REGULAR MEETING OF
THE PLANNING COMMISSION
DECEMBER 03, 2020 AT 6:00
PM
ATTEND VIRTUALLY

4. **Case #2020-2775. 1620 Agua Fria Street Romero Final Subdivision.** Liaison Planning Services, Inc., Agent, for Carlos and John Romero, Owners, requests approval of a final subdivision plat for 7 single-family residential lots located at 1620 Agua Fria Street. The property is zoned R-5 (Residential- five dwelling units per acre) and is approximately 1.47 acres. (Lee Logston, Case Manager, llogston@santafenm.gov, 955-6136).

Land Use Department Planning Commission Staff Report

DATE	SCALE	SHEET
OCTOBER 2020	N.T.S.	6-2

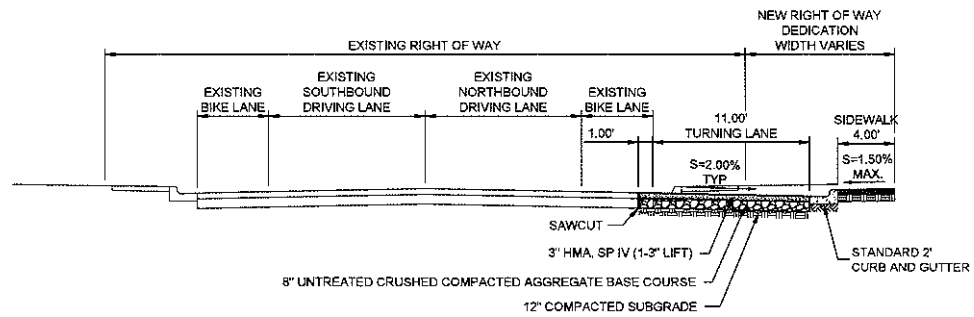
Conditions of Approval :	Must be completed by:
1 Pages 6-2 and 6-3 details 4-foot sidewalks; 5-foot sidewalks are the required minimum for both road types (lane/secondary arterial) by the City of Santa Fe Land Development Code; see Table 14-9.2-1: Design Criteria for Street Types, (Ord. No. 2013-16 § 59)	Prior to Signature Sheet Process
2 Page sheet 11-1 shows 4' bike lane on Agua Fria, however, page 6-2 is unclear or suggests a 1' bike lane. City code specifies bike lanes should be 5' minimum for this road type.

DATE: OCTOBER 2020 SCALE: 1" = 10' SHEET: 11-1

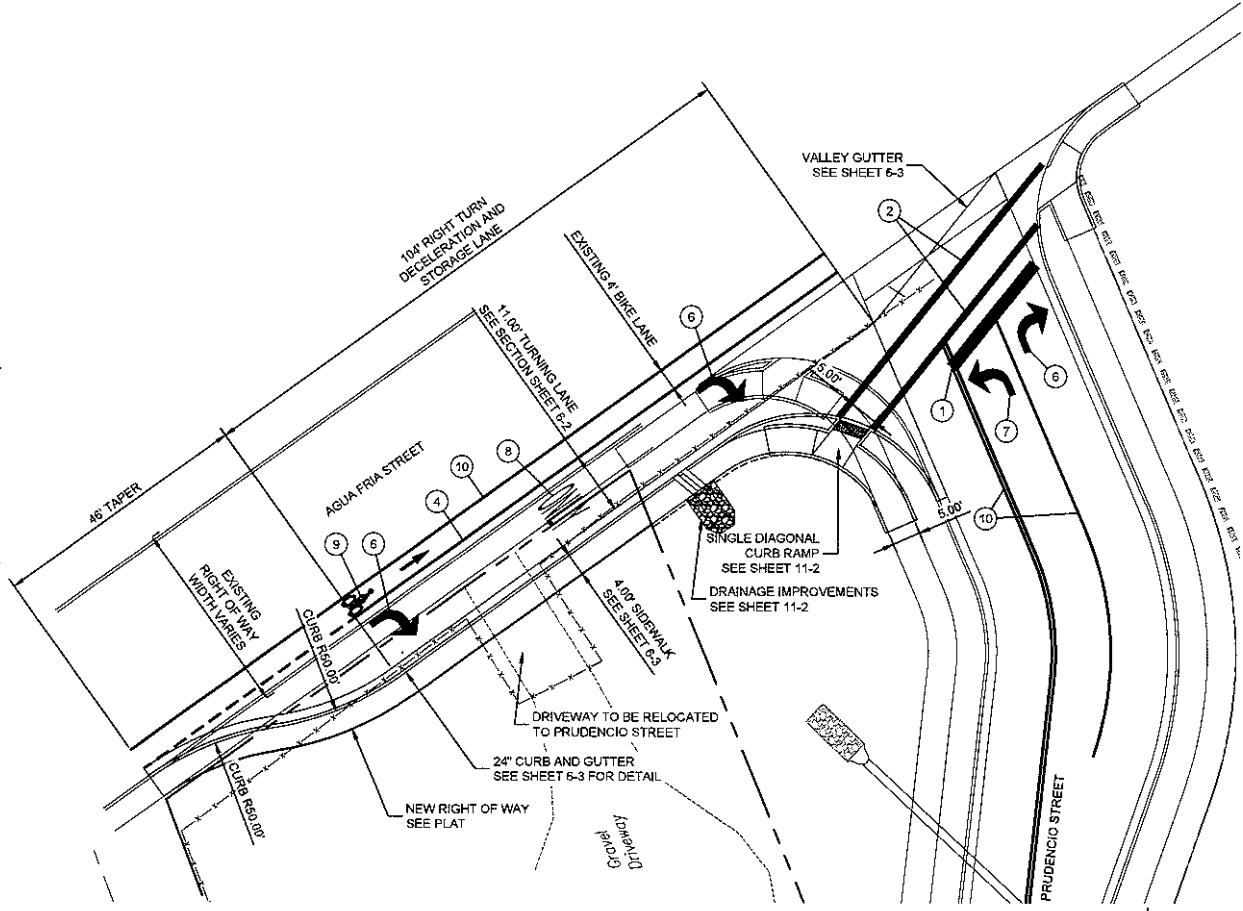
5	Page sheet 11-1 shows 4' bike lane on Agua Fria, however, page 6-2 is unclear or suggests a 1' bike lane. City code specifies bike lanes should be 5' minimum for this road type.	Land Use/MPO	Prior to Signature Sheet Process
